LOCAL HISTORIC DISTRICT: Dilworth

PROPERTY ADDRESS: 315 East Boulevard

SUMMARY OF REQUEST: New construction

Charlotte Historic District Commission Case 2017-393
HISTORIC DISTRICT: DILWORTH
NEW CONSTRUCTION

HDC-15

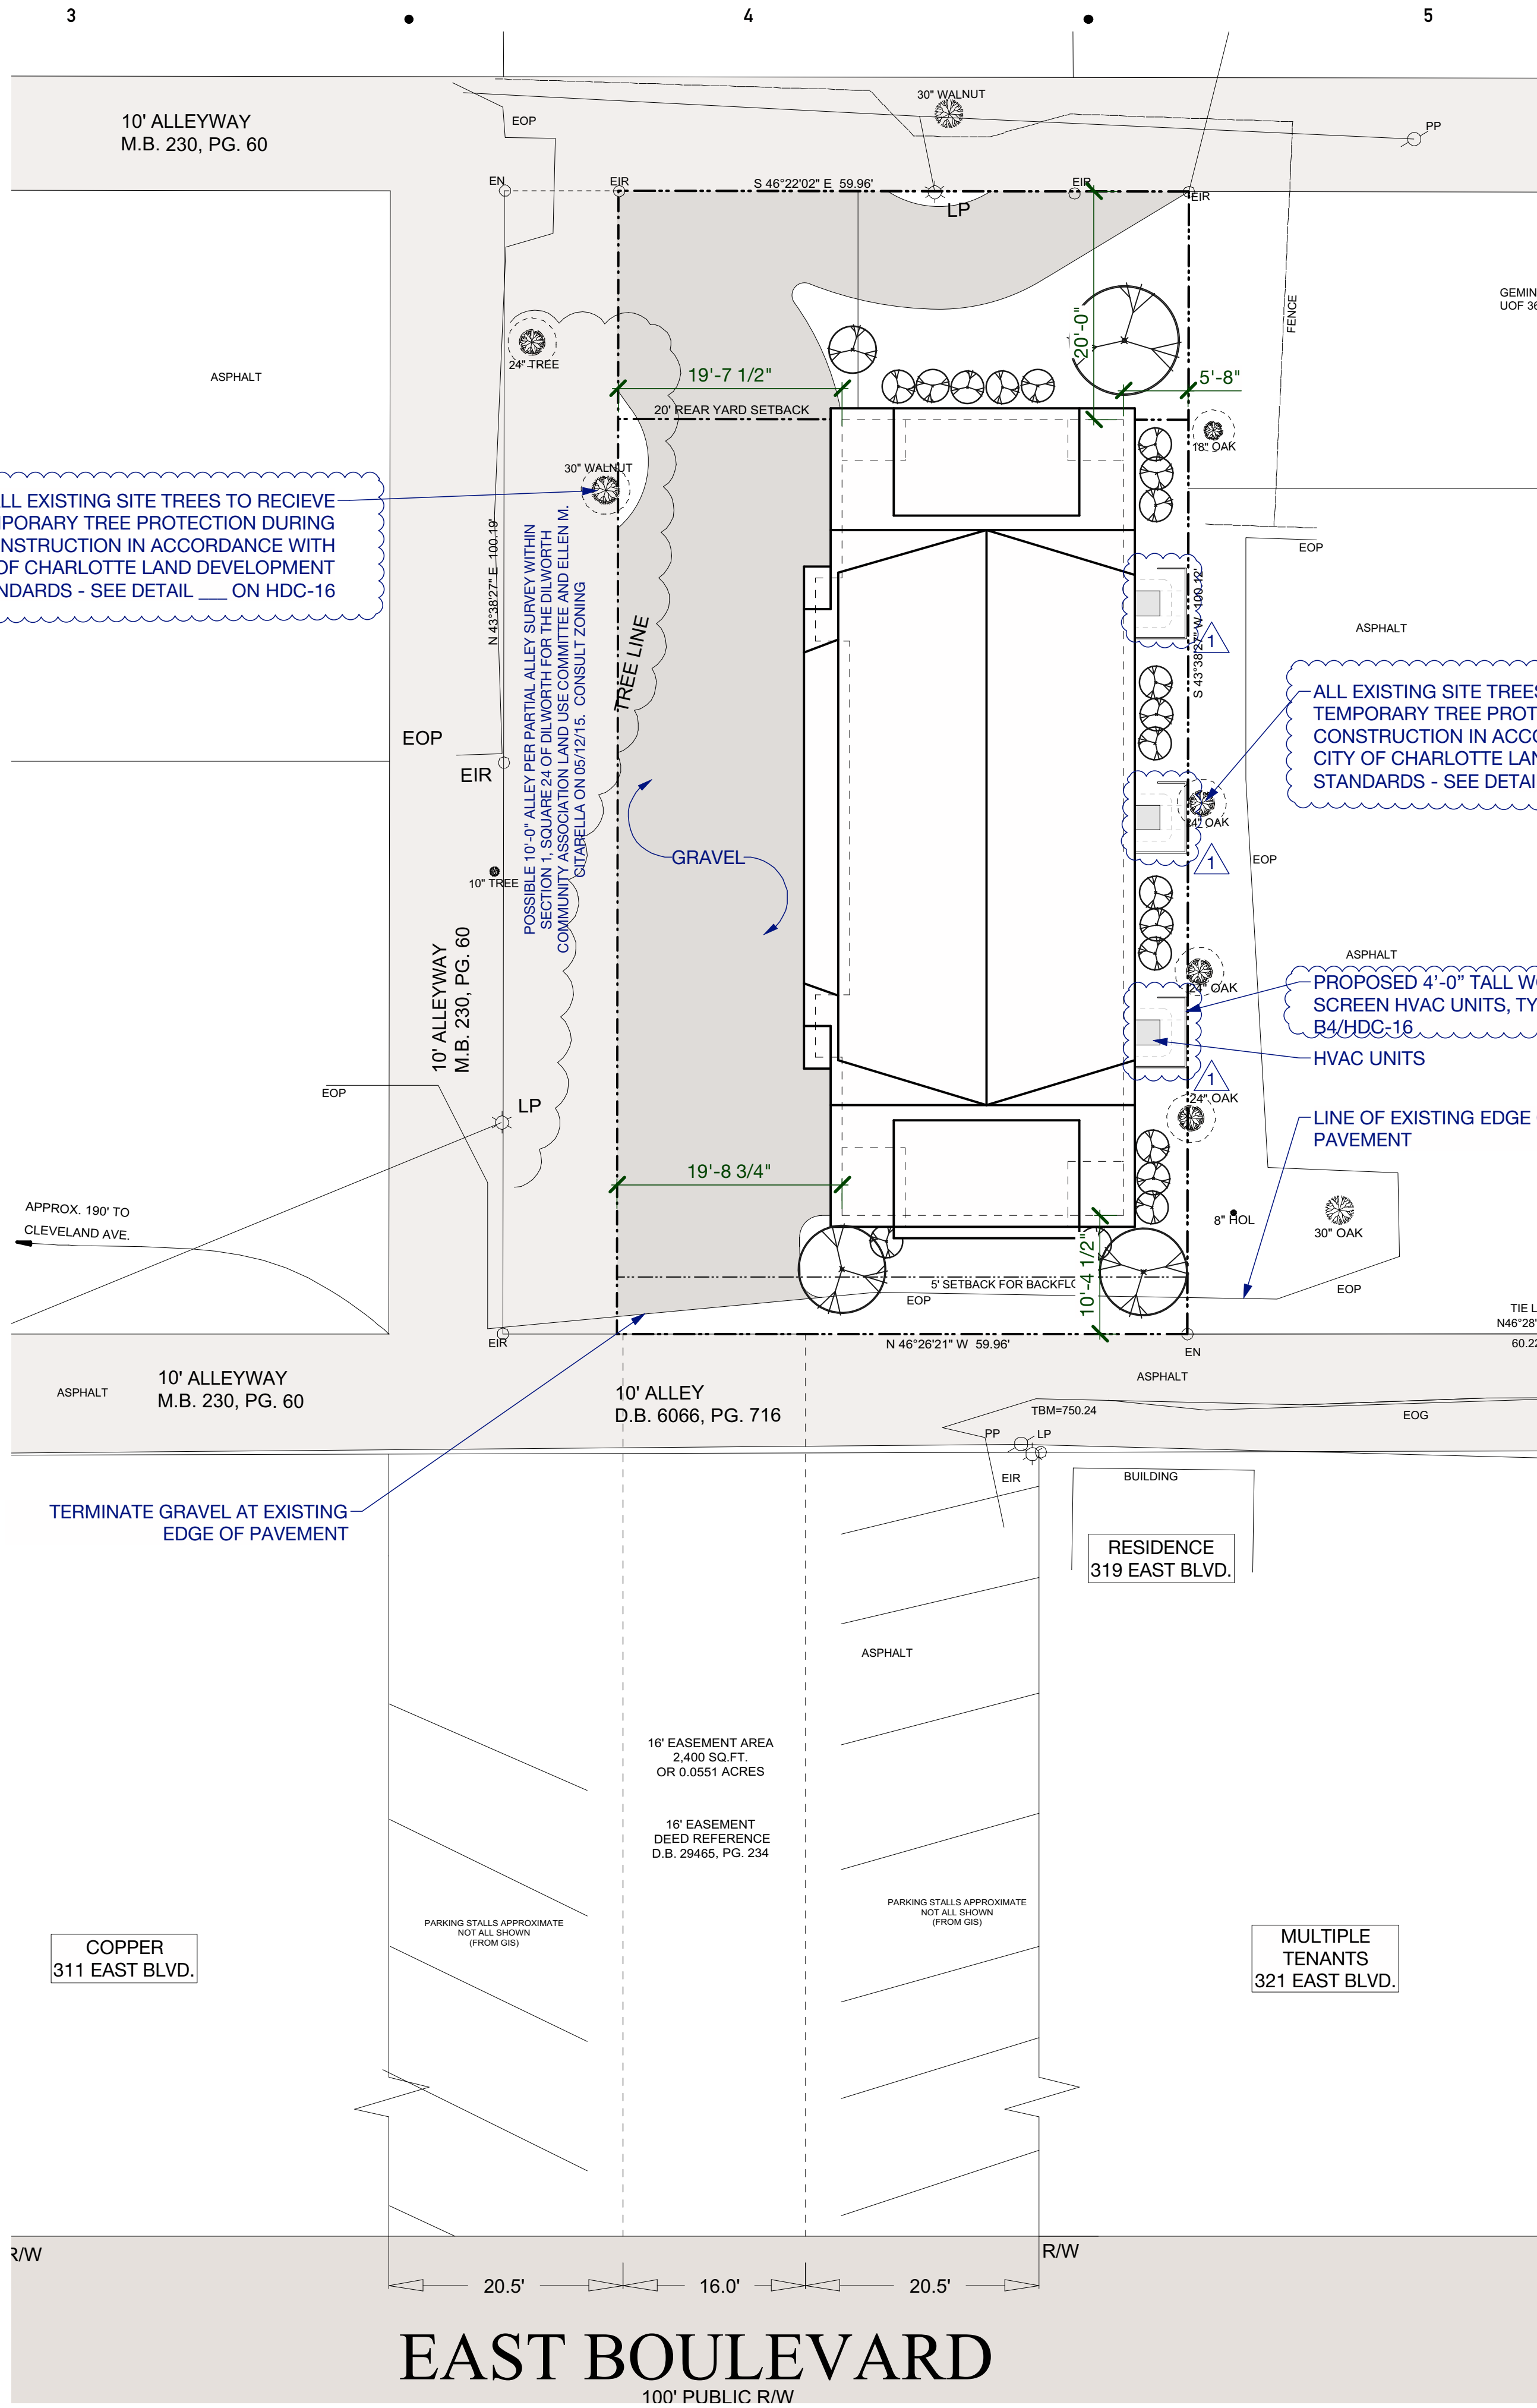
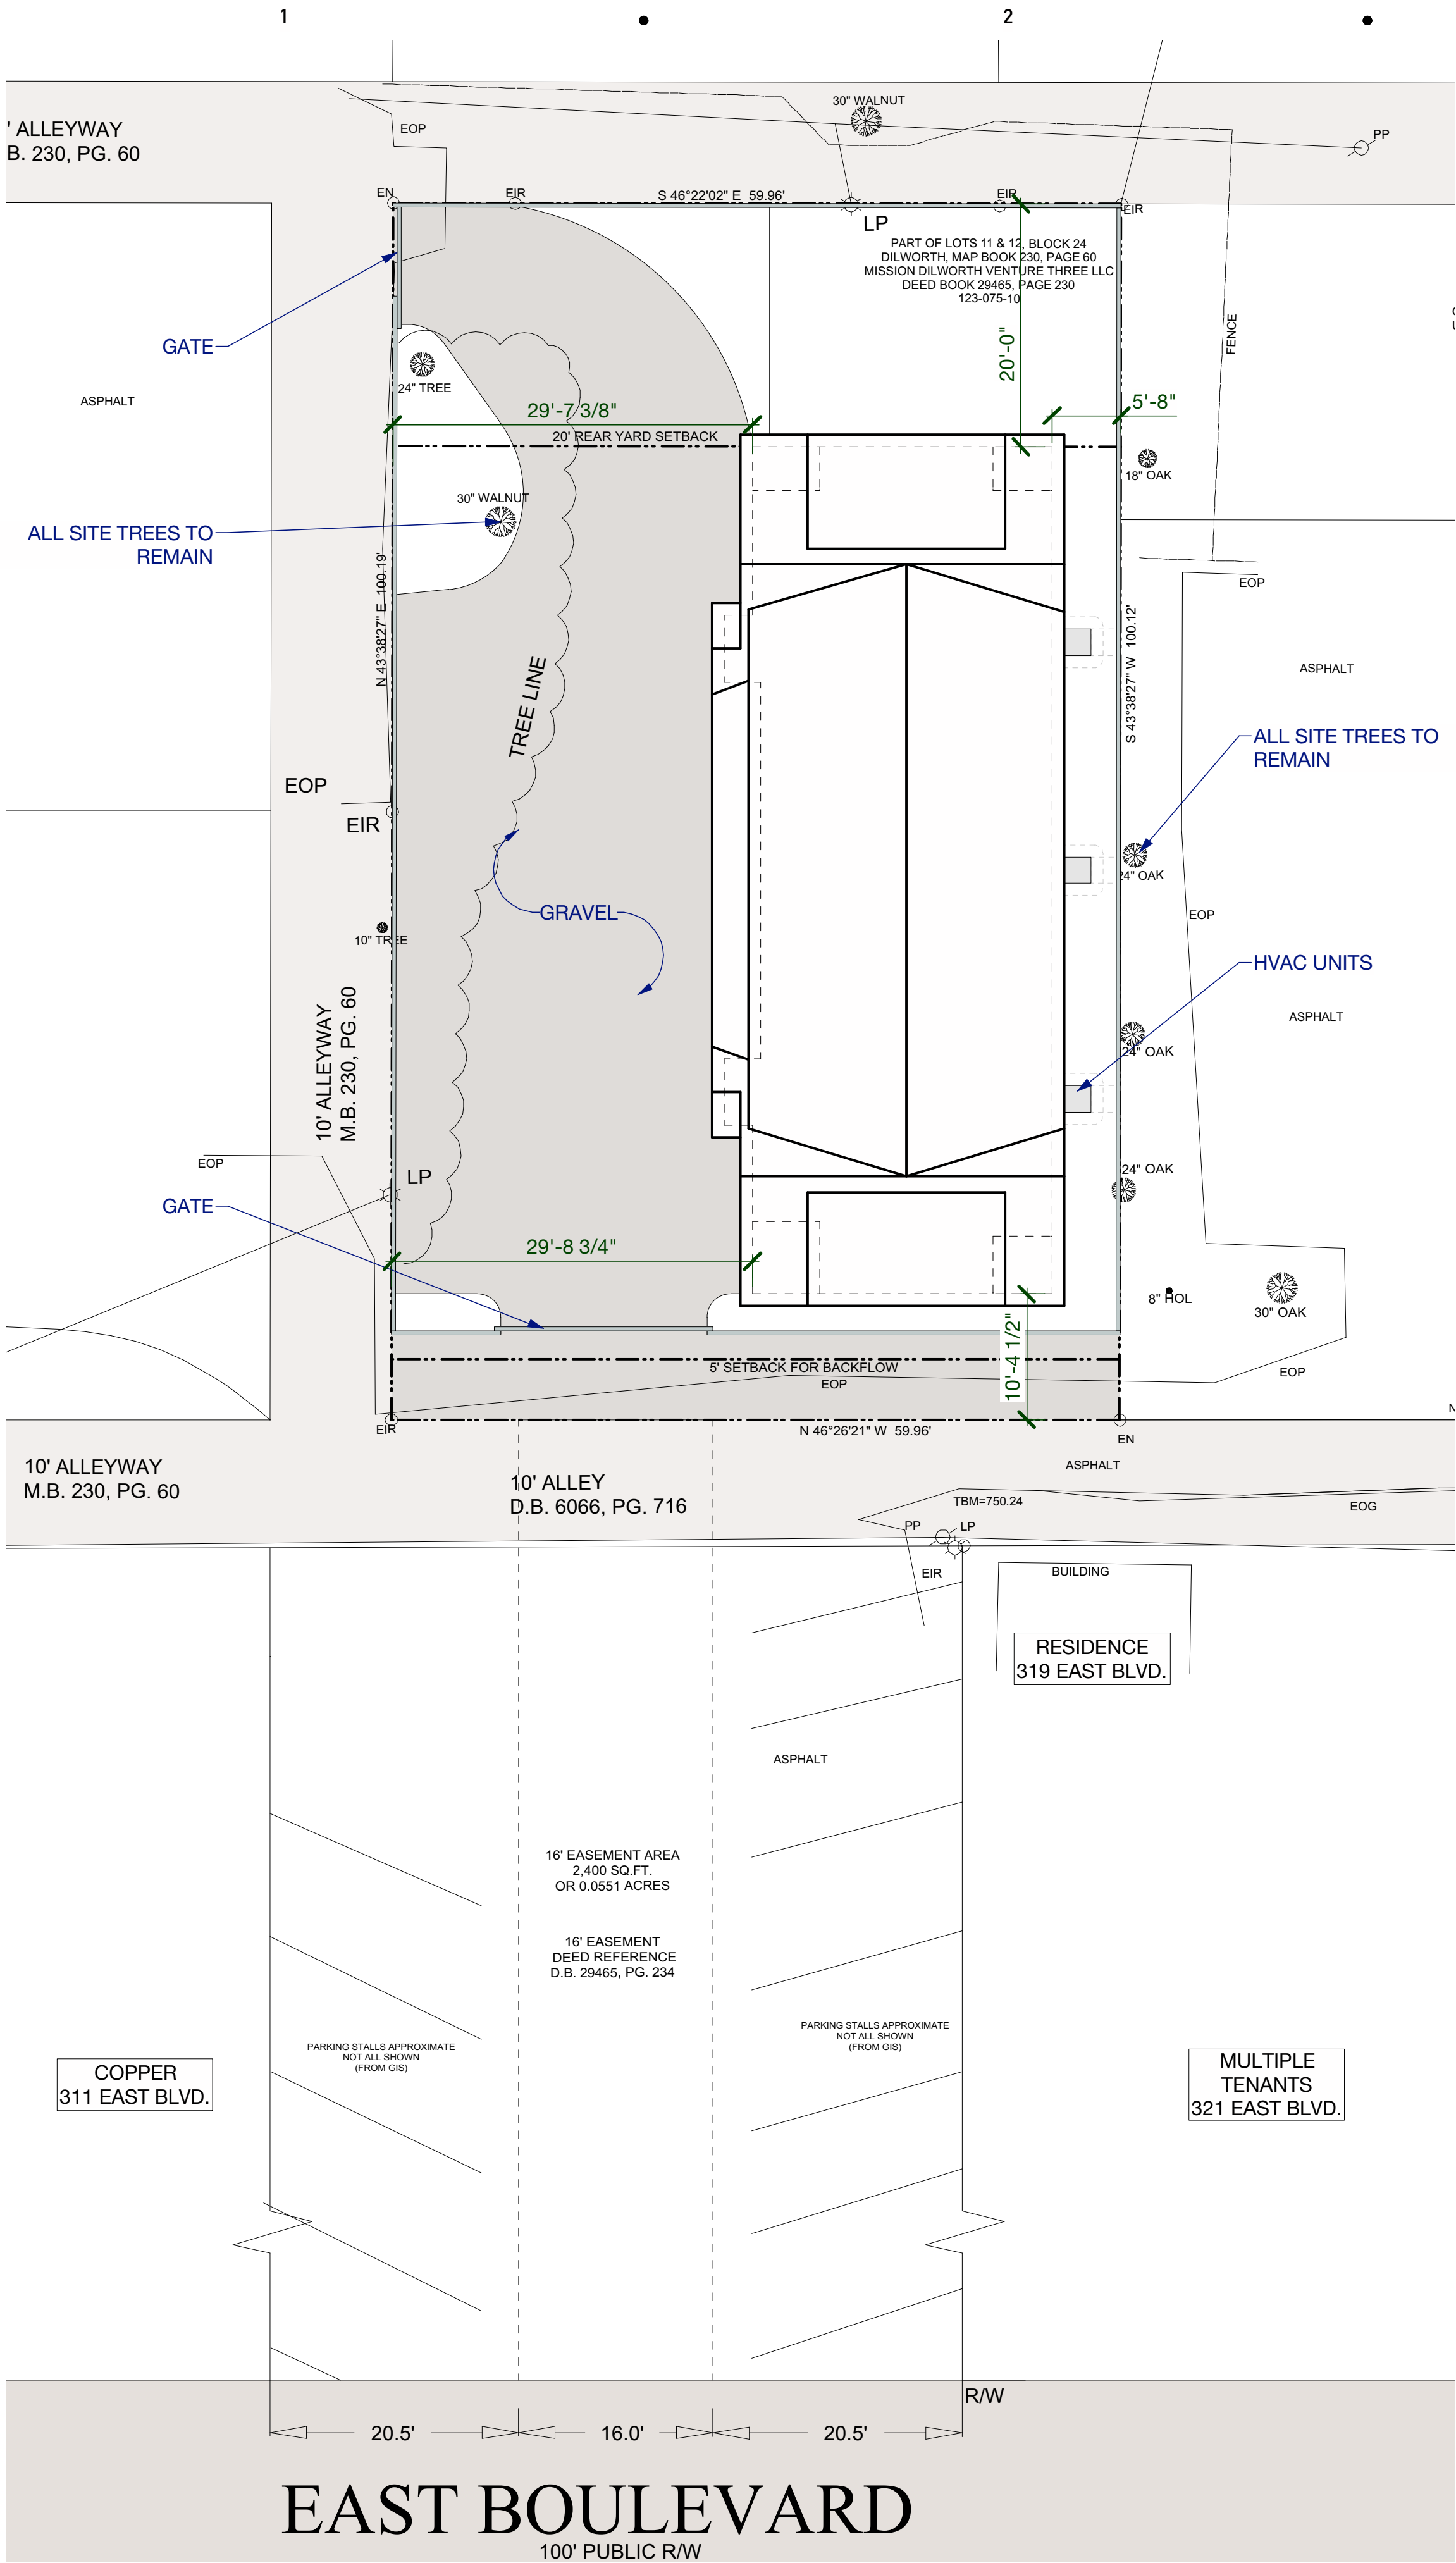
The application was continued from July for the following: 1) Provide an additional site plan that shows a 20' easement abutting the parking lot, revised fence and gate location, 2) landscaping plan, 3) tree protection plan, 4) Provide screening for AC units, 5) Eliminate the window aprons, 6) Consider design options for the elevation facing 315 East Boulevard.

- Provide an additional site plan that shows a 20' easement abutting the parking lot, revised fence and gate location
- Landscaping plan
- Tree protection plan
- Provide screening for AC units
- Eliminate the window aprons
- Consider design options for the elevation facing 315 East Boulevard

1. Sheet #HDC-15 – The additional 10' easement has been included.
2. Sheet #HDC-15 – AC screening is included
3. Sheet #HDC-15/16 – Landscaping and tree protection plan is included
4. Sheet #HDC-20 – East Boulevard elevation has been revised
5. Sheet #HDC-15 – Window trim has been revised
